**CITY OF LA VISTA**  
**MAYOR AND CITY COUNCIL REPORT**  
**JANUARY 21, 2020 AGENDA**

<b>Subject:</b>	<b>Type:</b>	<b>Submitted By:</b>
CONDITIONAL USE PERMIT – CASEY'S RETAIL COMPANY – LOT 3 HARRISON HILLS (118 <sup>TH</sup> & HARRISON ST)	◆ RESOLUTION ORDINANCE RECEIVE/FILE	CALE BRODERSEN ASSISTANT PLANNER

PCUP 19-0004

RE: Conditional Use Permit – Initial Review Response Letter  
Proposed Casey's – 118<sup>th</sup> & Harrison  
Lot 3, Harrison Hills  
Convenience Store & Gas Station  
Schemmer Project No. 06754.064

AL-101

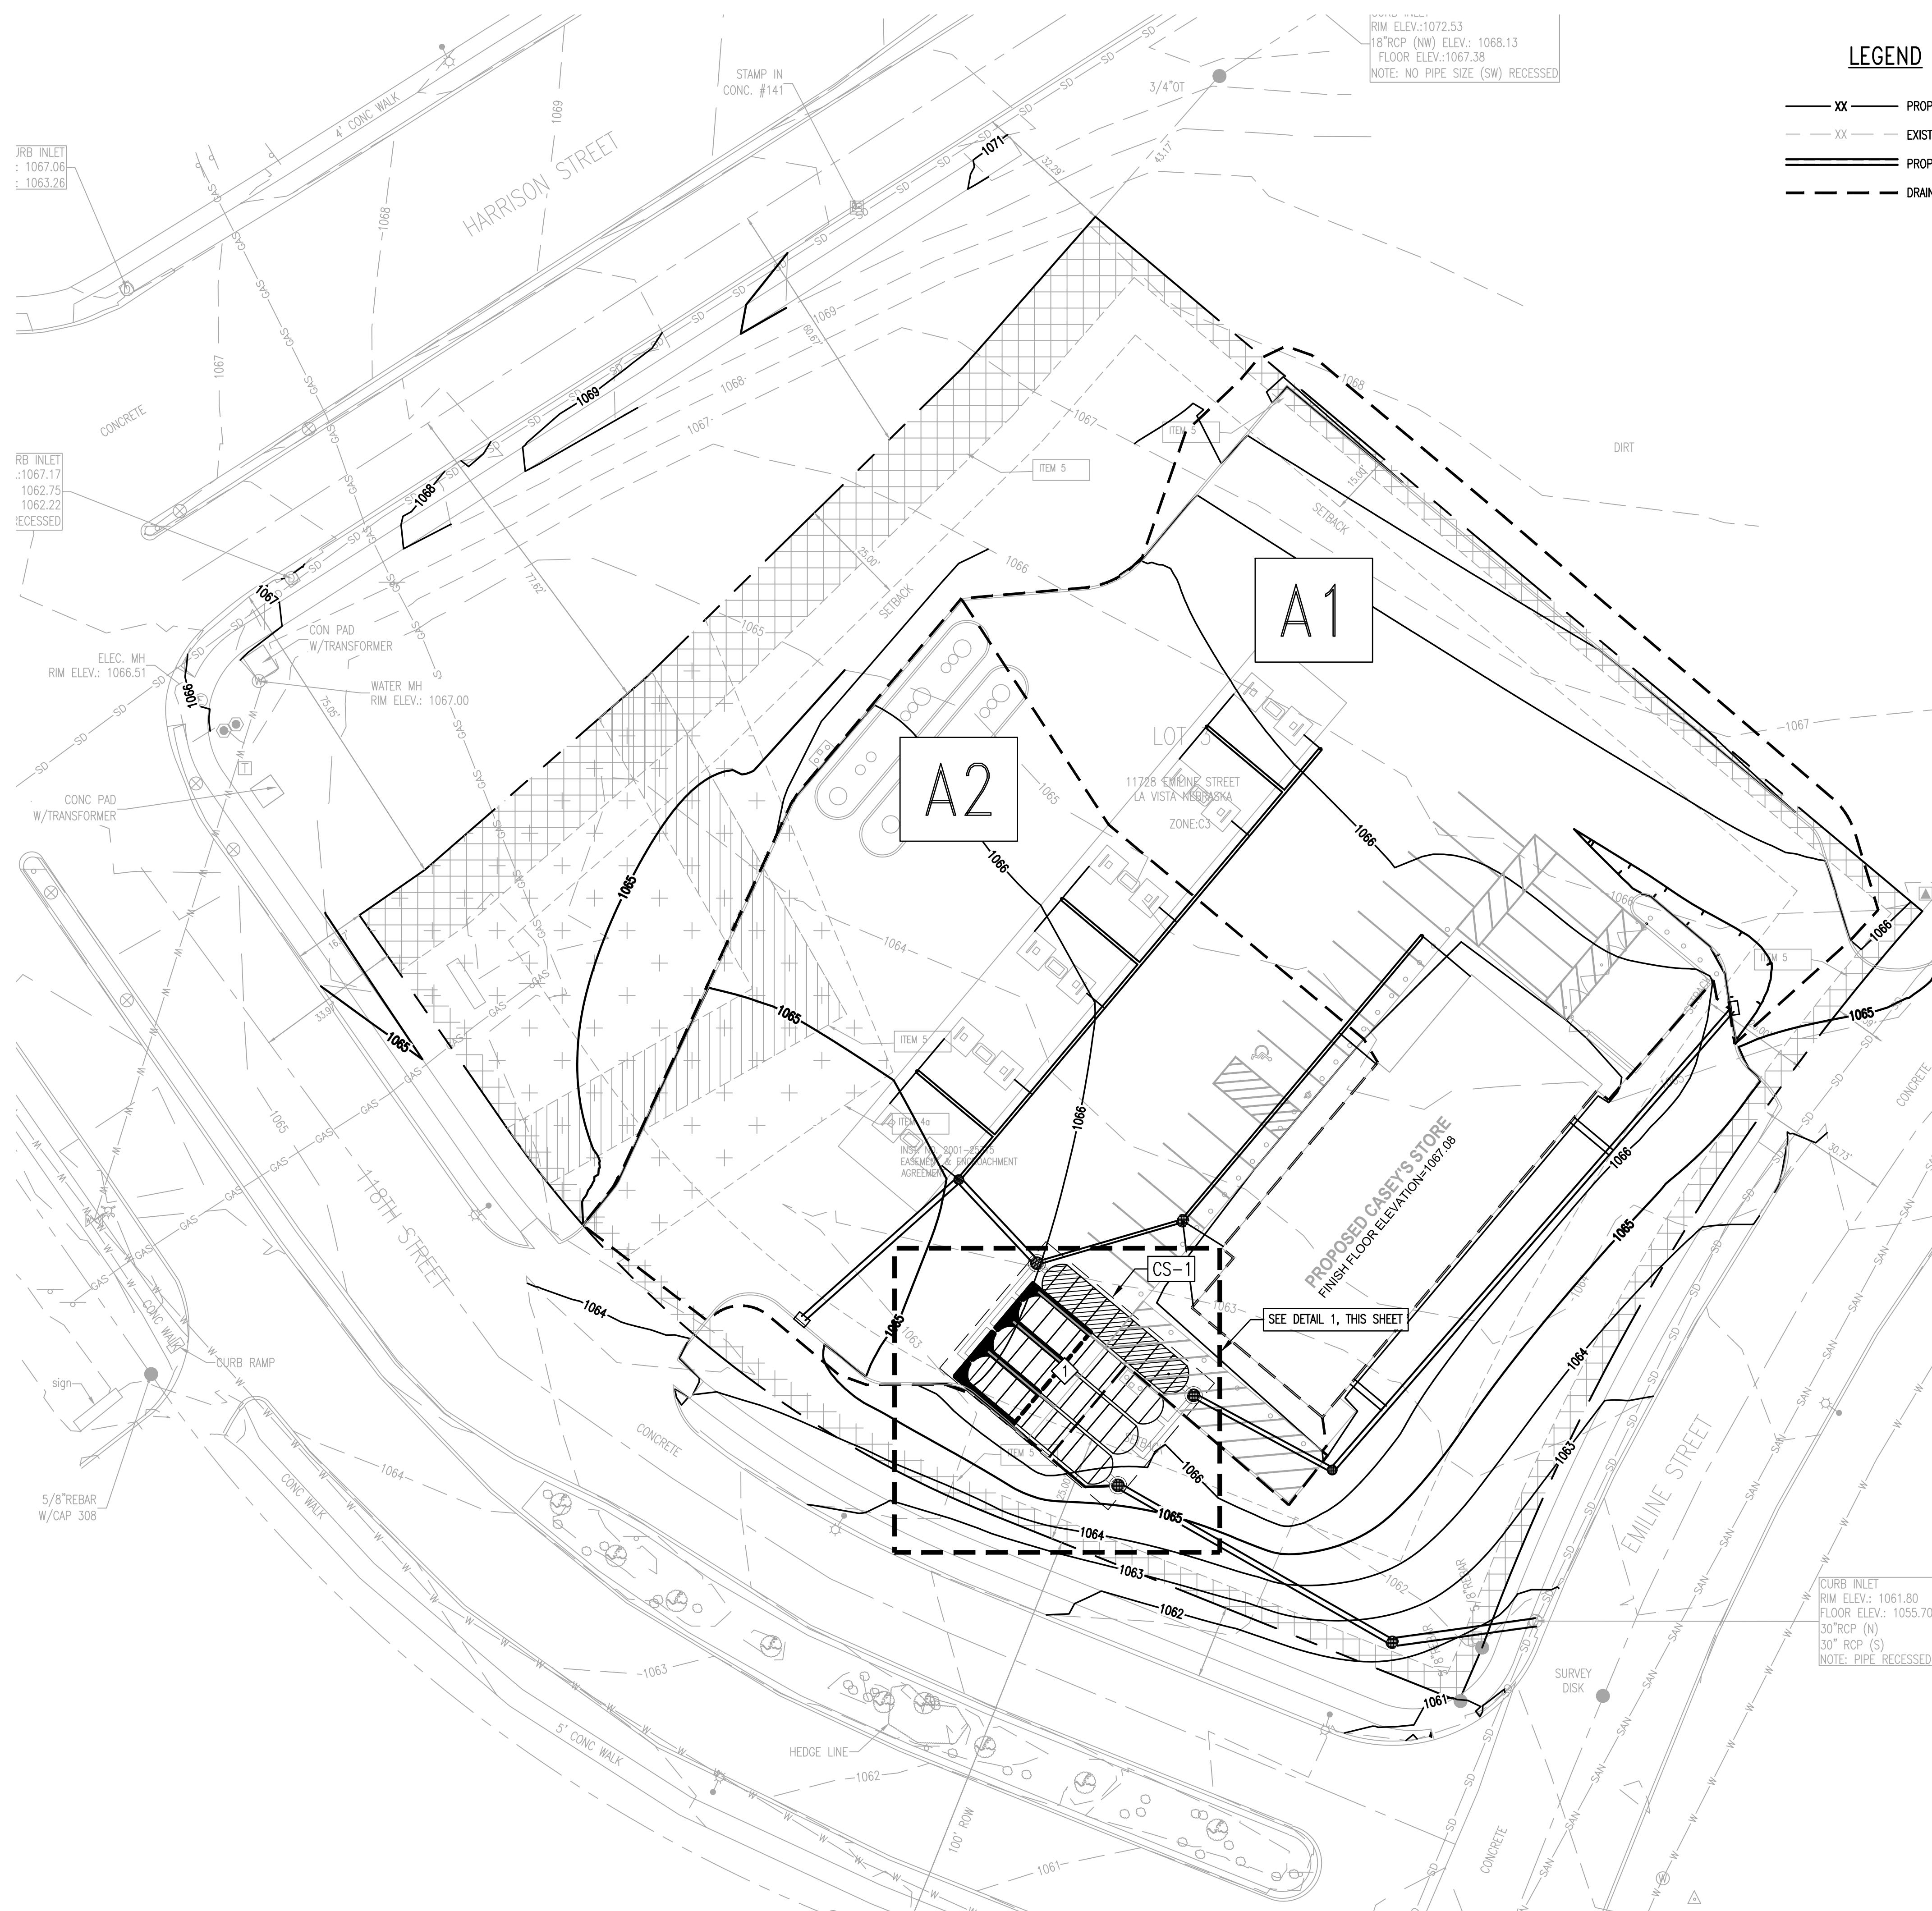
5. In regards to Article 6.05.09, site lighting will be reviewed as part of the design review process.
6. The zoning listed on the site plan needs to be revised to include "Gateway Corridor District (Overlay District)".

7. Strike "Misc. Notes" #1 as the dumpster design will be handled through the design review sheet set.
8. Strike "Misc. Notes" #2 as the signage will be handled outside of the Conditional Use Permit approval process.

- a. We acknowledge that the site lighting will be review as part of the design review process.
- 6. The zoning listed on the site plan needs to be revised to include "Gateway Corridor District (Overlay District)".

- a. The zoning listed on the site plan has been revised to include "Gateway Corridor District (Overlay District).
- 7. Strike "Misc. Notes" #1 as the dumpster design will be handled through the design review sheet set.

- a. We removed this note from the site plan.
- 8. Strike "Misc. Notes" #2 as the signage will be handled outside of the Conditional Use Permit approval process.

1 STORMTECH UNDERGROUND STORAGE SYSTEM CS-1 (ENLARGED PLAN)  
SCALE: 1"-10'

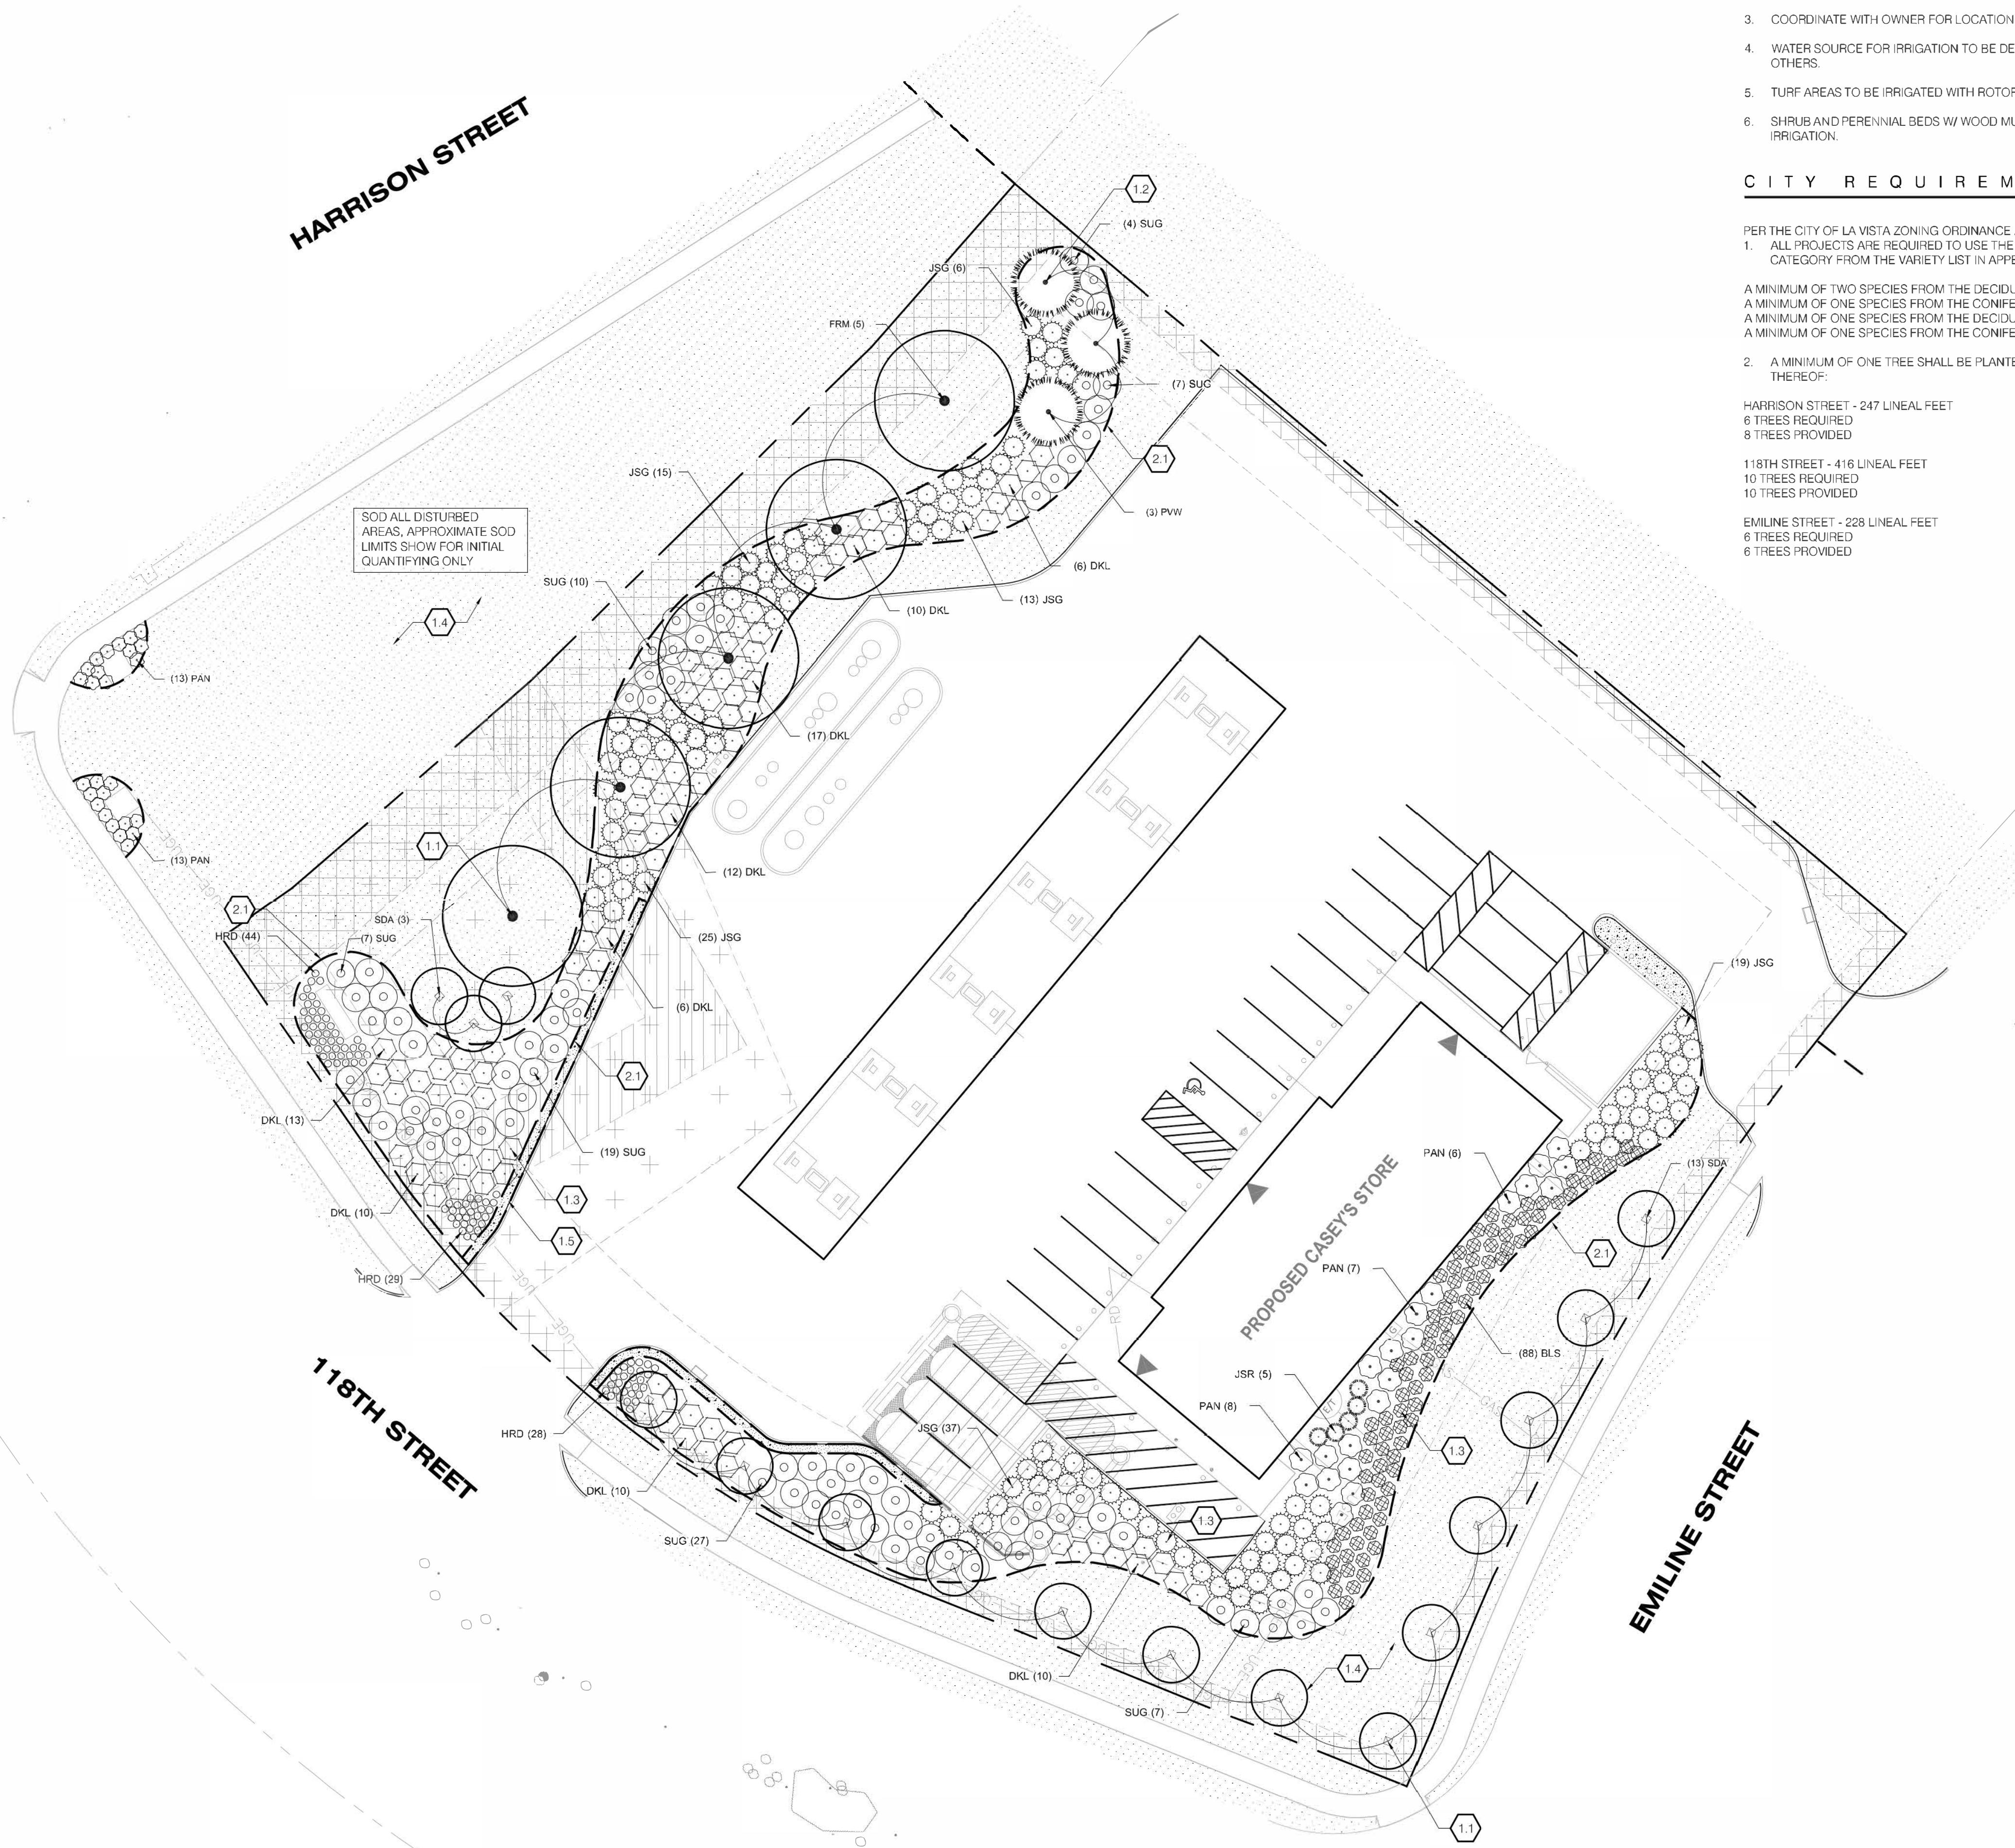
3. Regarding Articles 6.05.04, the proposed Site Layout Plan needs to identify type and location of best management practices that will be used to address water quality and no increase in 2-year storm event peak flows above pre-development conditions. Detailed design is not required, just an indication as to how this will be addressed.

- a. A StormTech® underground detention system is proposed for this site. A Post Construction Stormwater Management Plan is attached to this email.
- 4. Regarding Article 6.05.03, the Site Layout Plan proposes a shared driveway with the adjoining Lot 4 to the east. The owner of the adjacent lot needs to provide a written statement that they are agreeable to the proposed shared access. A finalized easement including maintenance provisions will be required prior to issuing a building permit.
